Addendum No. 2

Twin Falls School District Harrison and Morningside HVAC

ADDENDUM NO. 02

Project Name: TFSD Harrison HVAC Replacement
Address: Twin Falls, Idaho

Sheet No:
A9.01

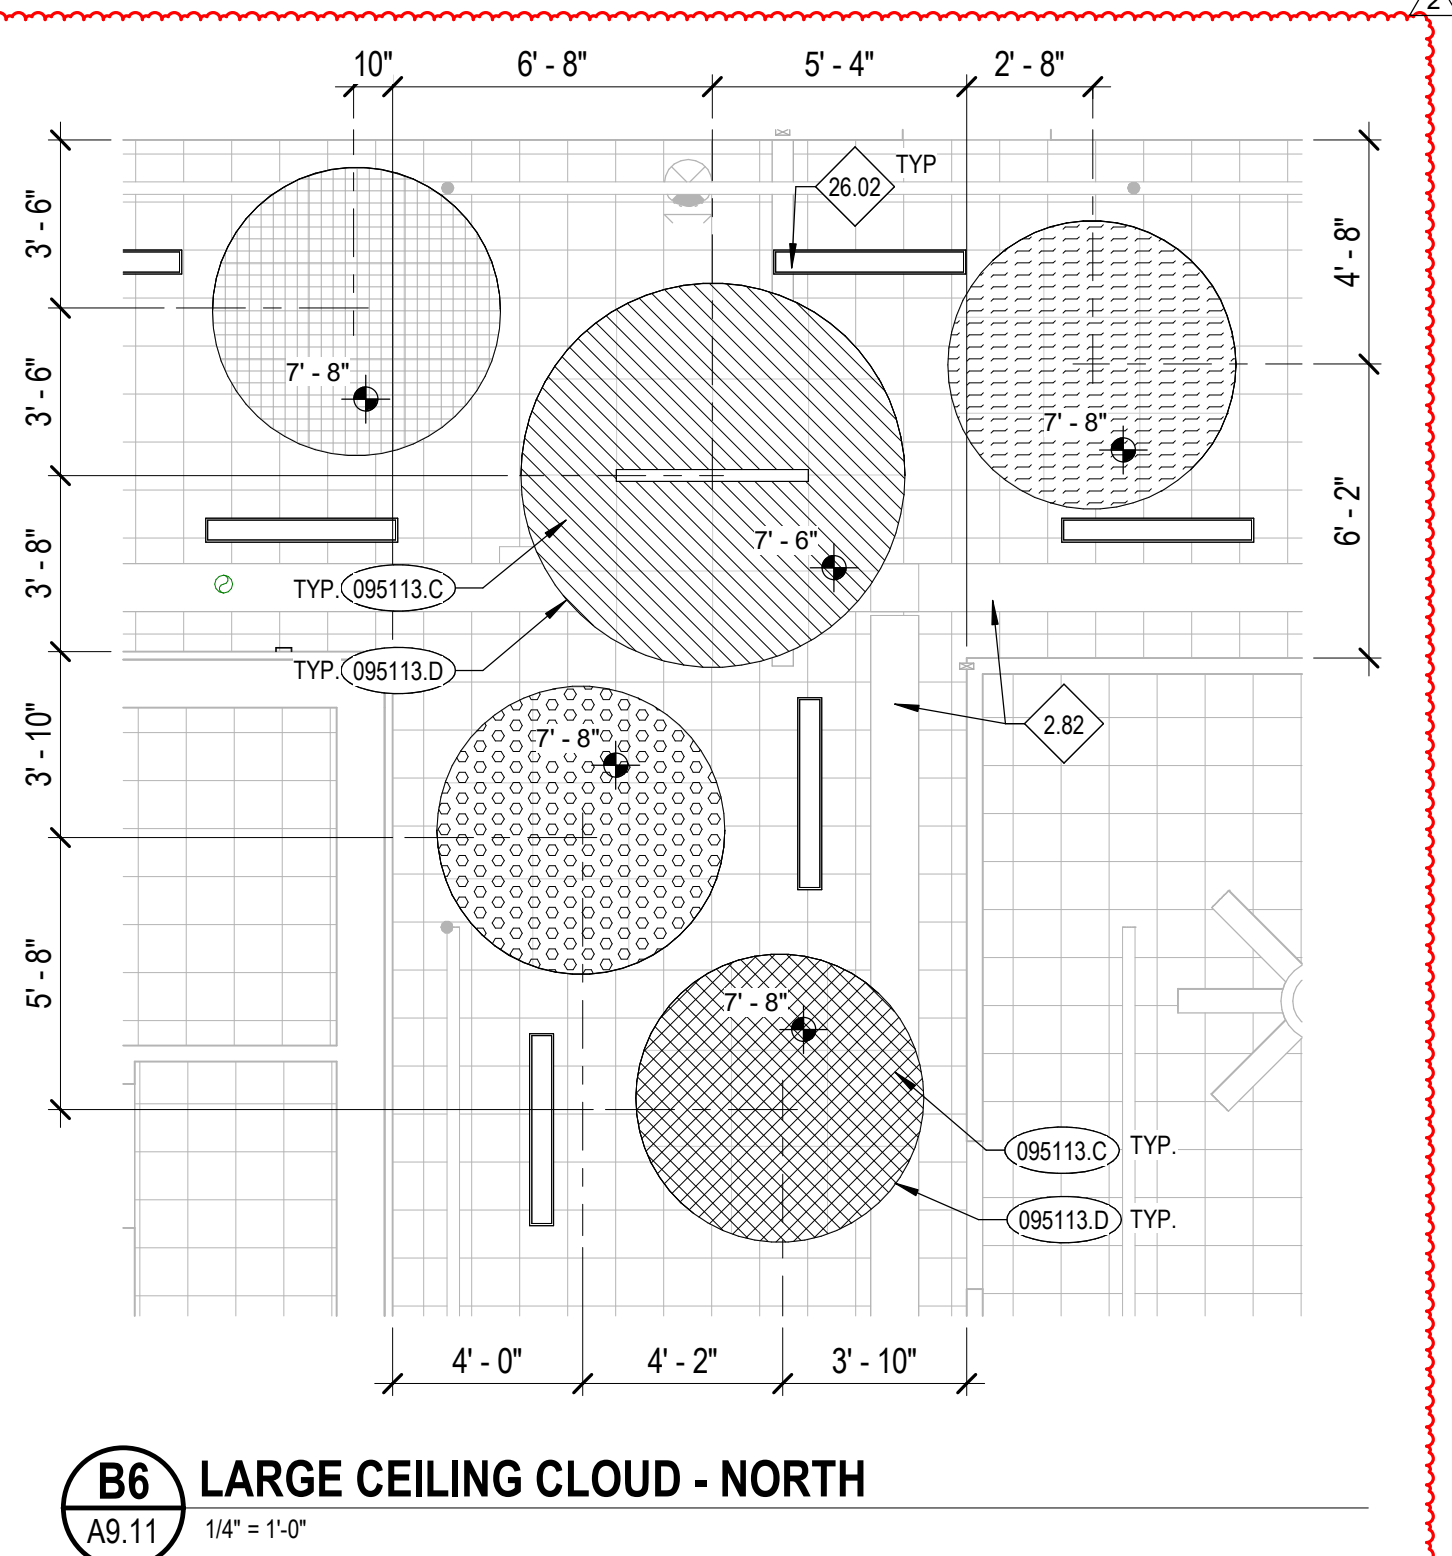
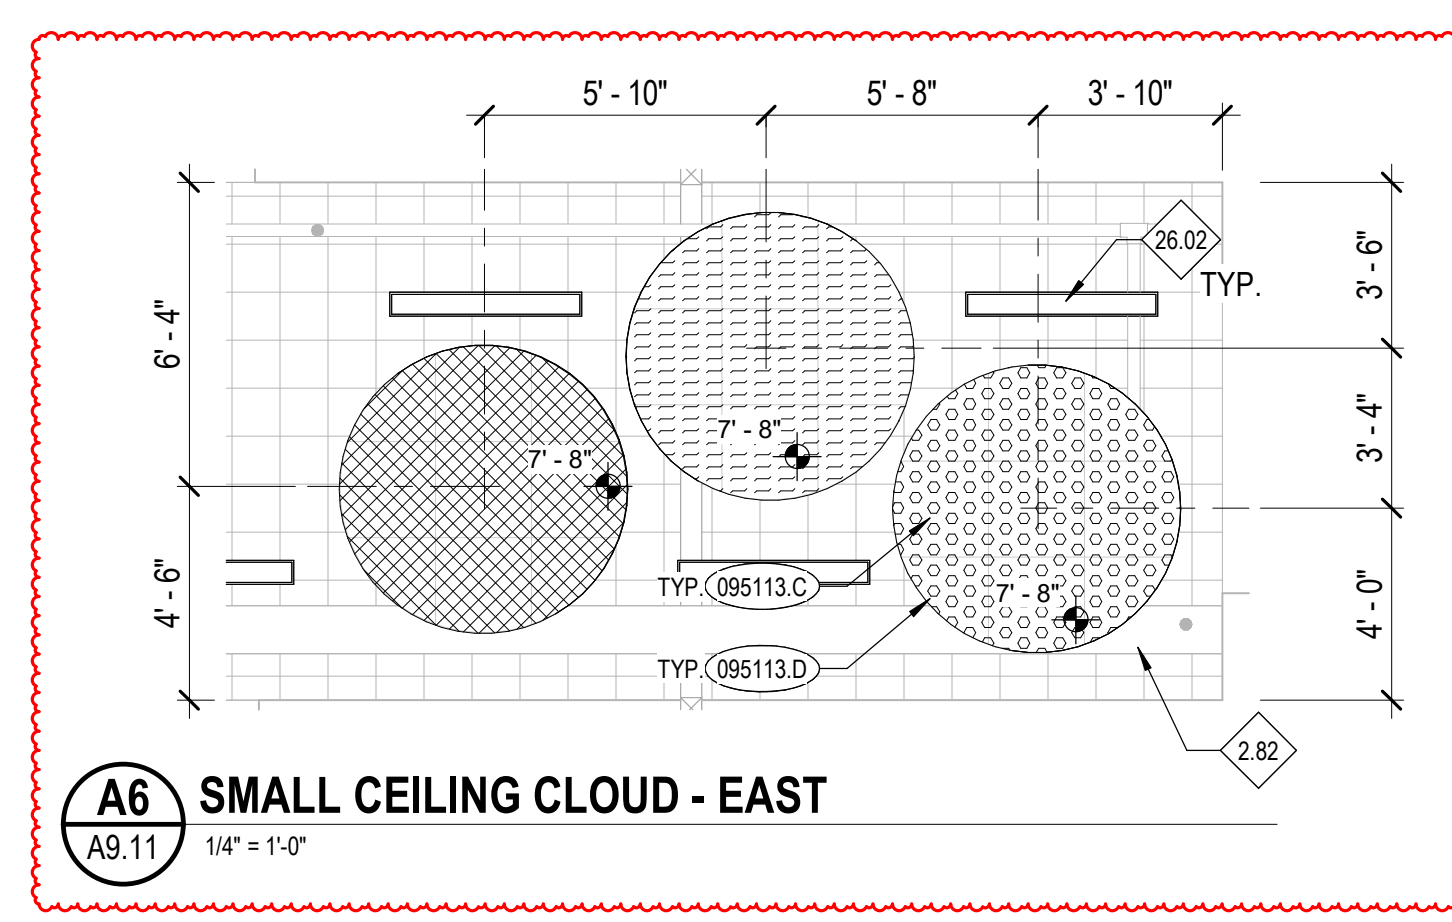
- **A9.01 – COMPOSITE CEILING PLAN**
 1. Change 4'-0" ceiling cloud to 6'-0" ceiling cloud
 2. Update ceiling grids from 2'-0" x 4'-0" grid to 2'-0" x 2'-0" grid.
- **A9.11 – AREA 'A' CEILING PLAN**
 1. Change 4'-0" ceiling cloud to 6'-0" ceiling cloud. Update dimensions and locations of ceiling clouds.
 2. Update ceiling grids from 2'-0" x 4'-0" grid to 2'-0" x 2'-0" grid.
- **A9.12- AREA 'B' CEILING PLAN**
 1. Change 4'-0" ceiling cloud to 6'-0" ceiling cloud. Update dimensions and locations of ceiling clouds.
 2. Update ceiling grids from 2'-0" x 4'-0" grid to 2'-0" x 2'-0" grid.

Sheet No: **A9.12**

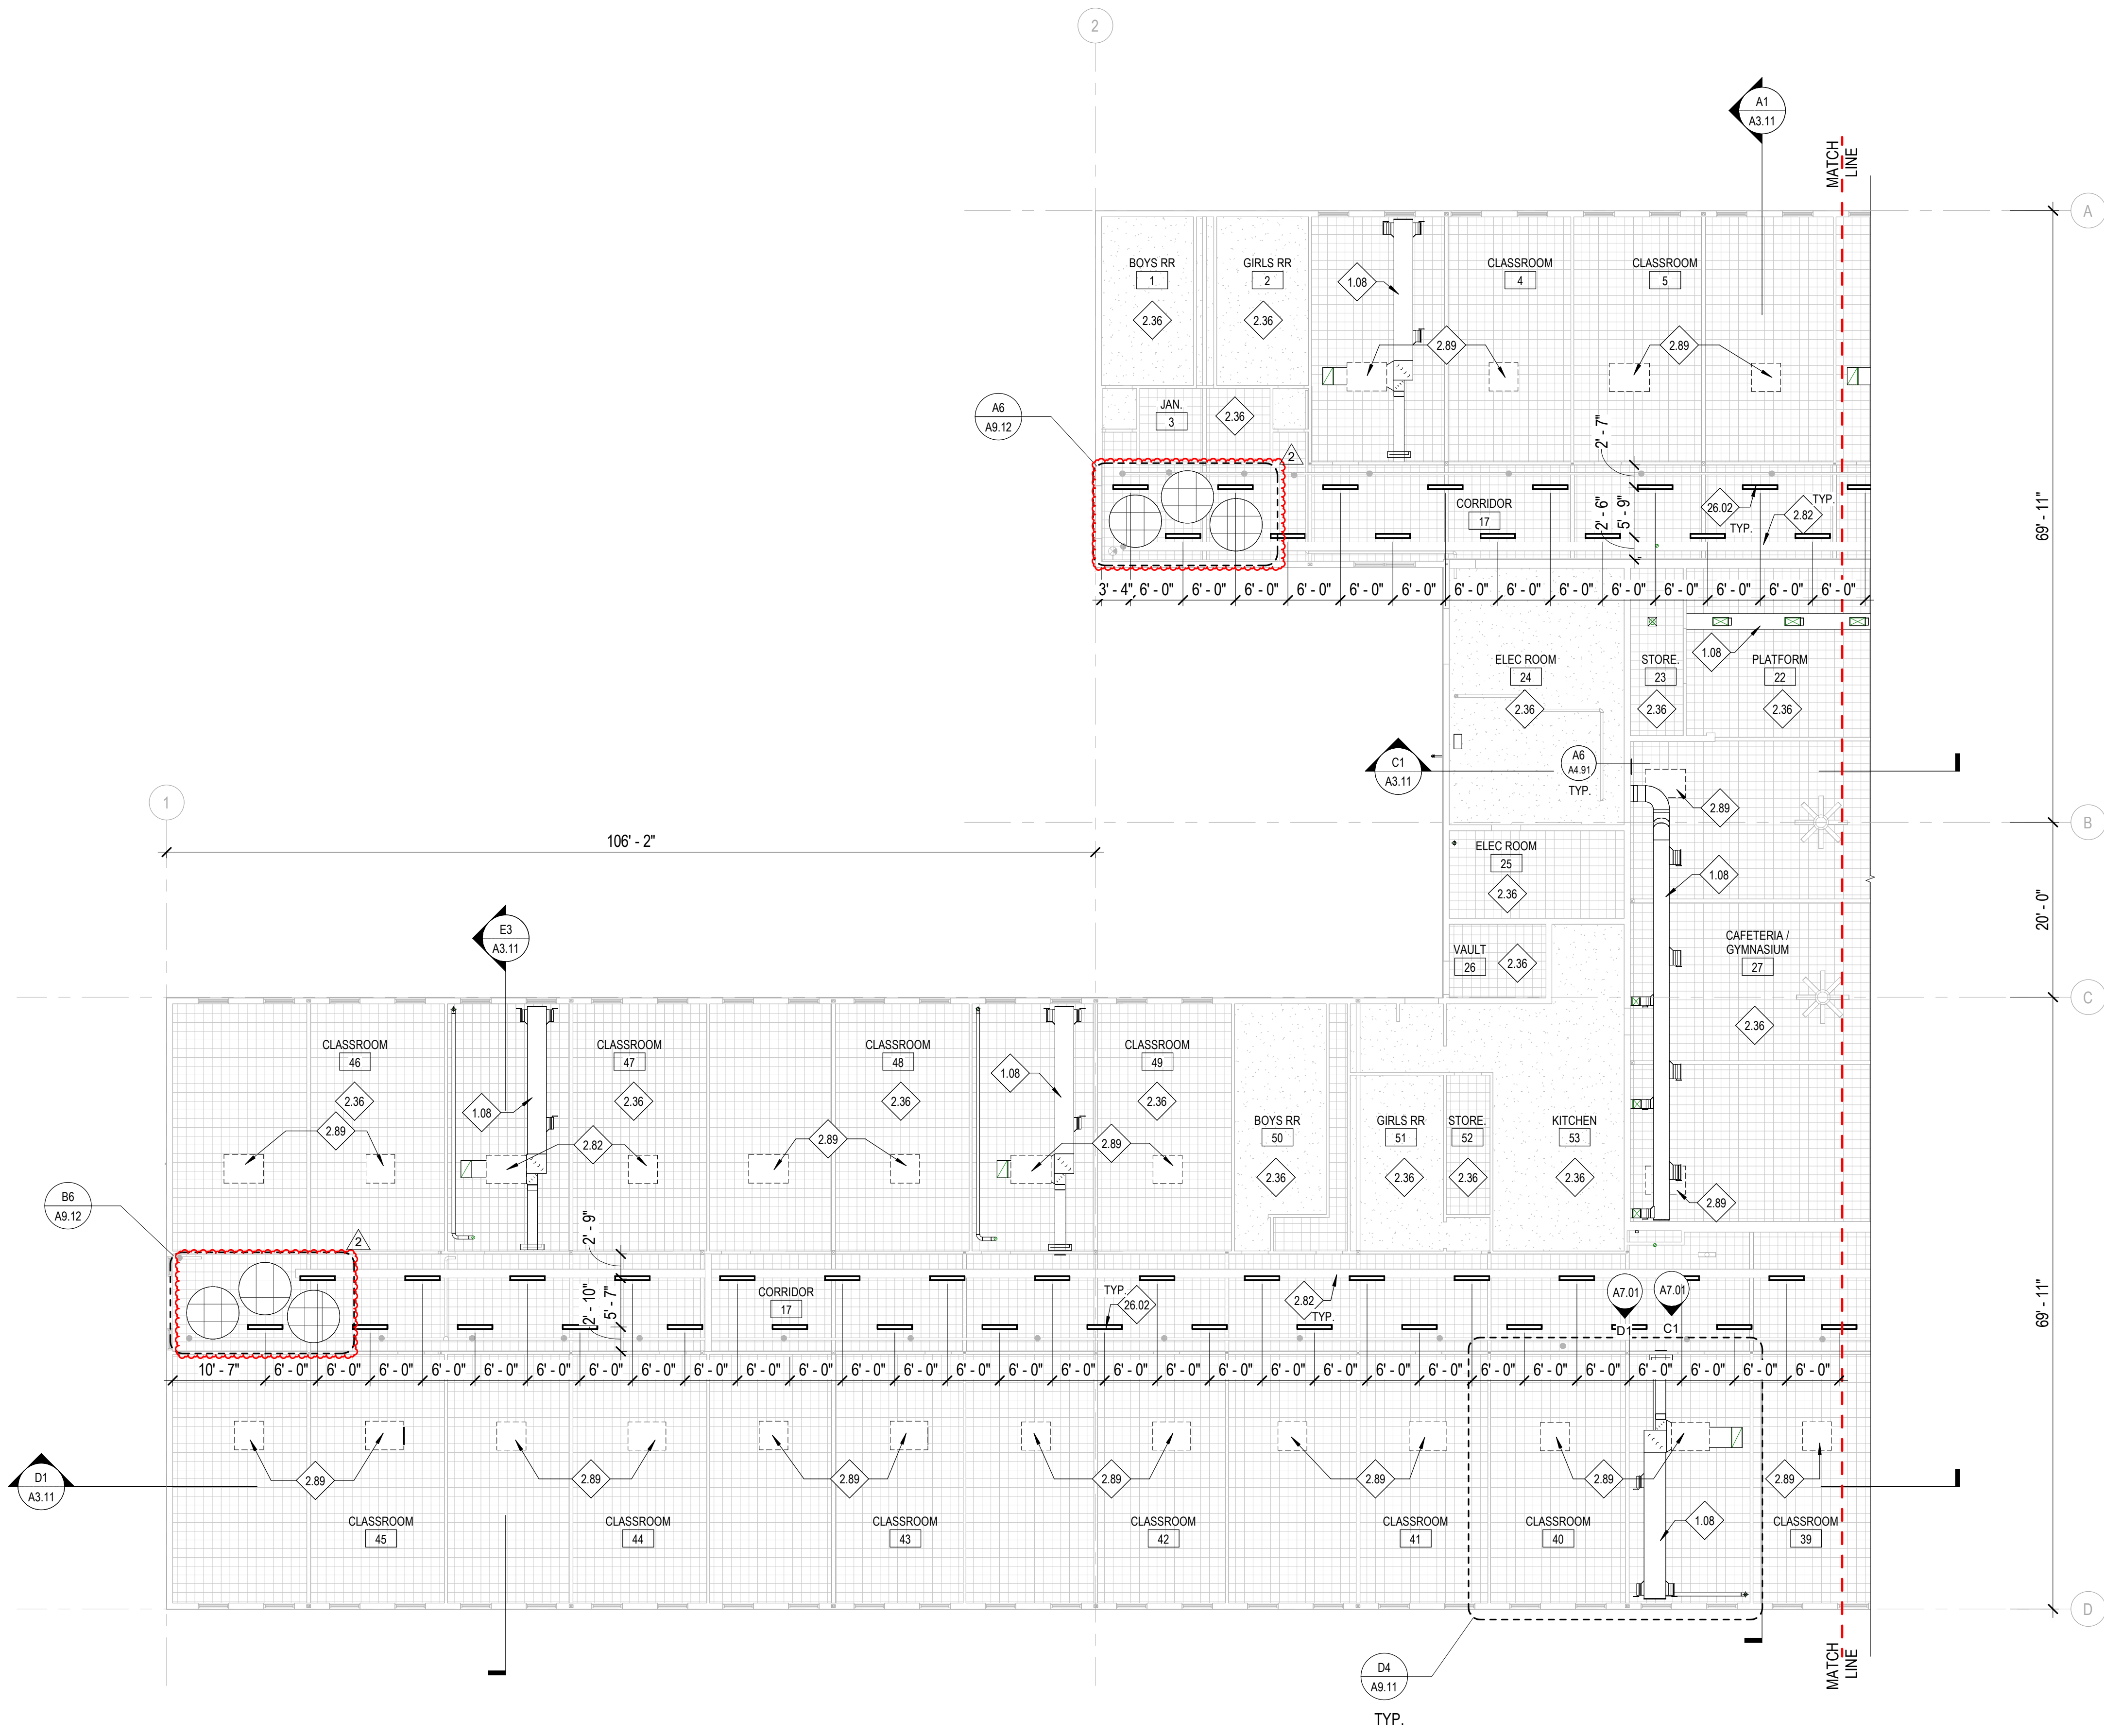
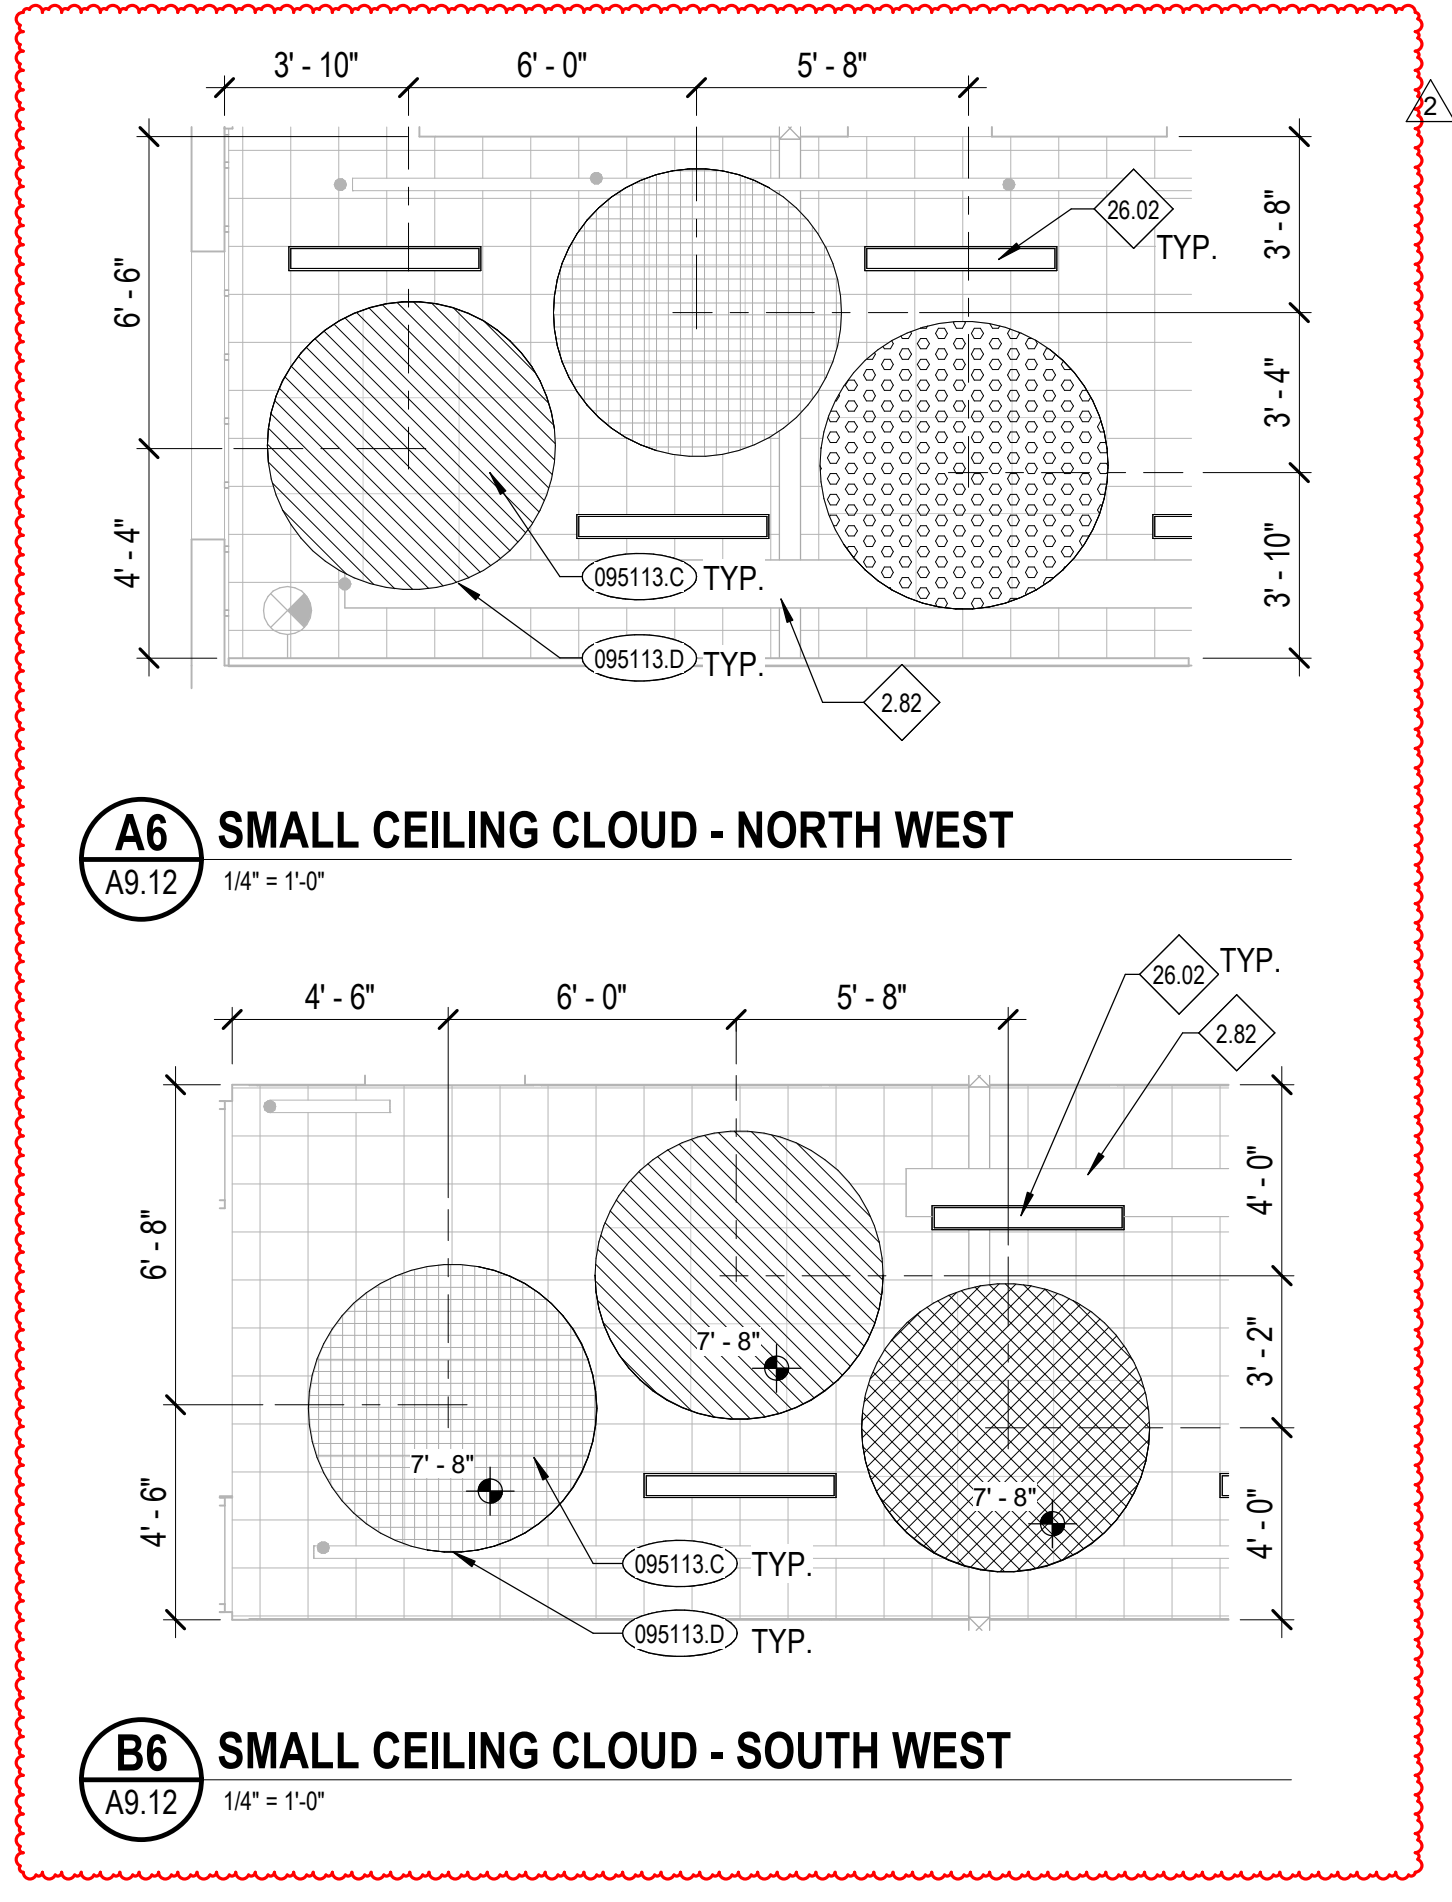
- See attached revised drawings for 2x2 grids at ceiling clouds.
- See attached revised drawings. Note that drawings indicate **6' and 8' DIAMETER**. Not radius.
